#### **BULLETIN: 29009**

## Lower Ball Joint Removal and Installation Issues

Ford Expedition, Explorer, Explorer Sport Trac, F-150, F-150 Heritage, F-250, Ranger / Lincoln Navigator / Mazda B2300, B3000 / Mercury Mountaineer

ENLARGED BALL JOINT RECEPTACLE IN LOWER CONTROL ARM, WHICH CAN CAUSE A LOOSE BALL JOINT FIT

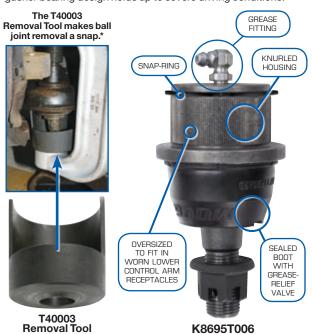
- When installing a replacement ball joint in these applications, technicians may note that the new ball joint may not fit tight in the opening of the lower control arm. The lower ball joint receptacle has been known to experience wear, especially when the ball joint has been replaced several times. If a traditional ball joint is installed in this situation, it will move and shift during operation, which can quickly wear out and damage the control arm, as well as causing unsafe handling issues.
- Lower ball joints in these applications are difficult to press out.
  When removing, an air hammer or chisel is not recommended as it can damage the control arm and the ball joint receptacle.

#### MOOG® K8695T006 Oversized Lower Ball Joint

- The ball joint is .006" oversized to fit in worn lower control arm receptacles.
- The snap-ring makes installation easy. The snap-ring in combination with the knurled housing keeps the ball joint securely in place. Use of an appropriate press tool is recommended.
- The greaseable design ensures fresh lubrication reaches the bearing surfaces while flushing contaminants, while the all-metal gusher bearing design holds up to severe driving conditions.

\* The T40003 is designed specifically for removal of the ball joint on these vehicles. If the incorrect ball joint press receiver is used, you could mushroom the housing of the old ball joint and further enlarge the control arm hole, requiring replacement of the control arm.
